APPEAL SUMMARY

Appeal ID: 24869	Project Address: 7250 NE Airport Way
Hearing Date: 5/12/21	Appellant Name: Scott Thayer
Case No.: B-009	Appellant Phone: 5037245294
Appeal Type: Building	Plans Examiner/Inspector: Elgin Rowland
Project Type: commercial	Stories: 6 Occupancy: S-2 Construction Type: II-B
Building/Business Name: PDX P3 Parking Garage	Fire Sprinklers: Yes - Only in certain Electrical Rooms
Appeal Involves: Erection of a new structure	LUR or Permit Application No.: 18-162599-CO
Plan Submitted Option: pdf [File 1]	Proposed use: Open Parking Garage

Appeal item 1

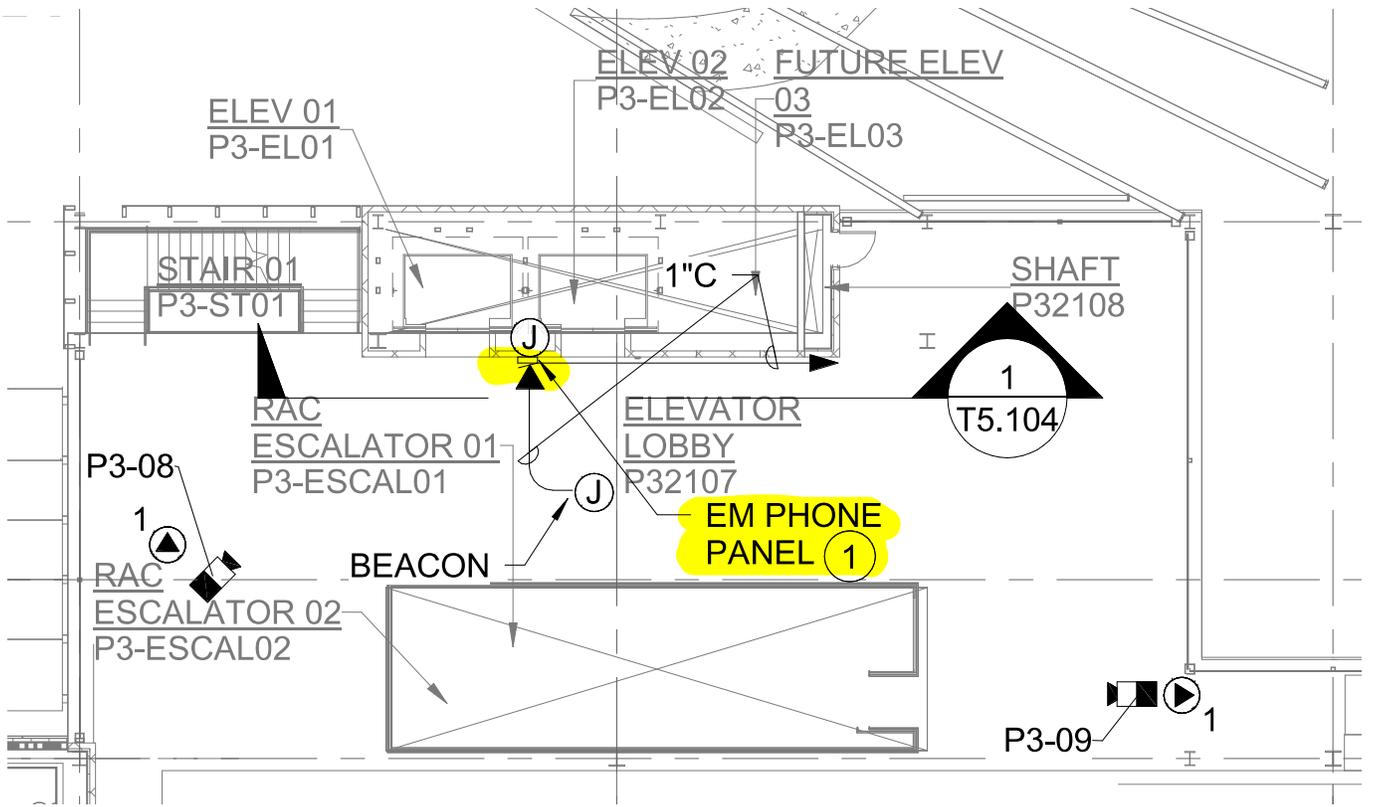
Code Section	2014 OSSC 713.8.1
Requires	713.8.1: Penetrations other than those necessary for the purpose of the shaft shall not be permitted in shaft enclosures.
Code Modification or Alternate Requested	Allow penetration of gypsum membrane on outside of Elevator Shaft Wall assemblies for specific junction boxes, based on 2019 OSSC code provisions and Engineering Judgement.
Proposed Design	<p>Provide recessed junction boxes penetrating outside gypsum membrane of elevator shaft wall assemblies, with fire sealant, in specific locations as follows:</p> <p>P3 NW Core Elevator Shaft P3-EL01/02/03 Levels 1-6: 8"x11" Emergency Phone J-Boxes P3 Central Core Elevator Shaft P3-EL04/05 Levels 1-6: 8"x11" Emergency Phone J-Boxes See attached plans for proposed locations, and attached Engineering Judgement for proposed fire sealant detail at the junction box membrane penetrations.</p> <p>2019 OSSC provides a relevant Exception to 713.8.1 as follows: 713.8.1, Exception: Membrane penetrations shall be permitted on the outside of shaft enclosures. Such penetrations shall be protected in accordance with Section 714.4.2. 714.4.2: Membrane Penetrations. Membrane penetrations shall comply with Section 714.4.1 (through penetrations). Where walls or partitions are required to have a fire-resistance rating, recessed fixtures shall be installed such that the required fire resistance will not be reduced.</p> <p>As an Open Parking Garage, the P3 Elevator Shaft Enclosures are not Fire Rated. Therefore the proposed outside membrane penetrations will not reduce the fire-resistance rating of these shaft enclosures. In addition we propose to provide fire sealant in the annular space around the perimeter of the J-boxes as shown in the attached Engineering Judgement (as provided for 2-Hr rated shaft enclosures).</p>

Equivalent code-required life safety and fire protection is provided by meeting the 2019 OSSC code provisions cited (per 713.8.1 and 714.4.2), and because the proposed membrane penetrations will not reduce the fire-resistance rating of the Elevator Shaft Enclosure. All shaft enclosures in the P3 structure are non-rated, as allowed in Open Parking Garages. Additional protection will be provided by installing fire caulking in the annular space around the perimeter of the J-boxes.

Junction box penetration of elevator shaft wall that is not necessary for the purpose of the shaft: Granted provided the junction boxes are installed in compliance with 2019 OSSC Section 714.4.2.

P3 NW CORE TYPICAL FLOOR - 8X11 EM PHONE BOX LOCATIONS SHEET T2.203

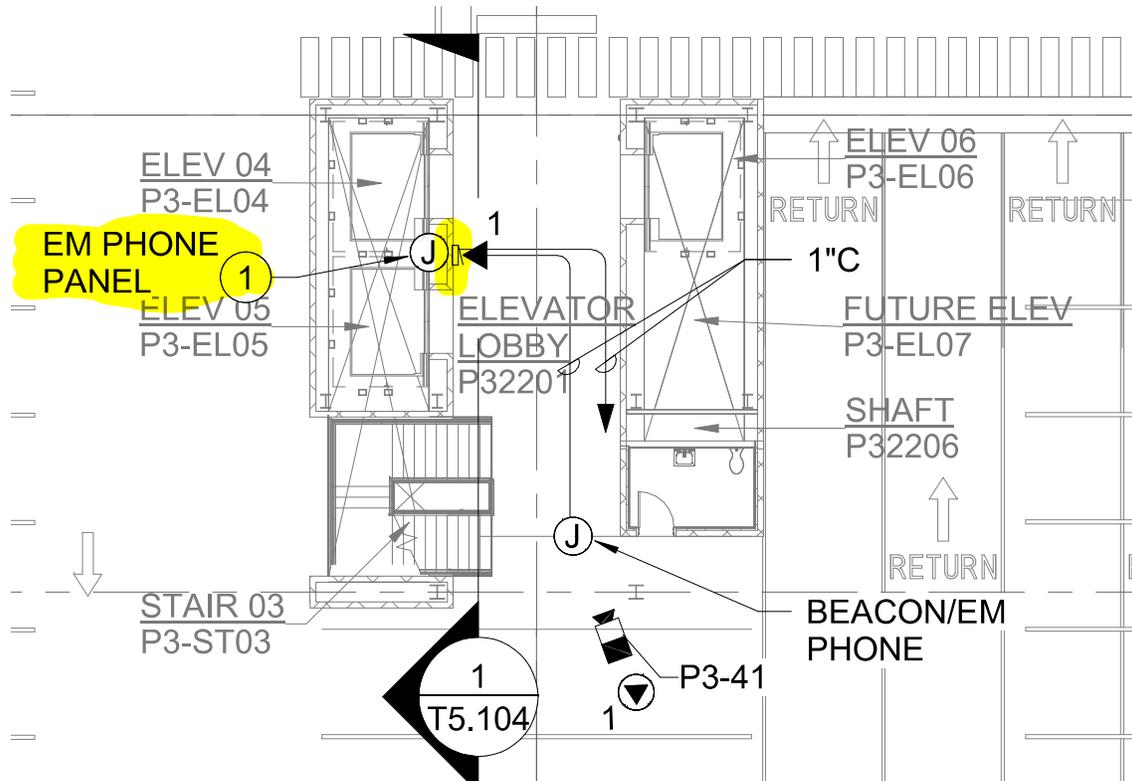
Recessing of the Emergency Phone boxes is required to avoid non-compliance with Accessibility Code limitations on projections from the face of wall.
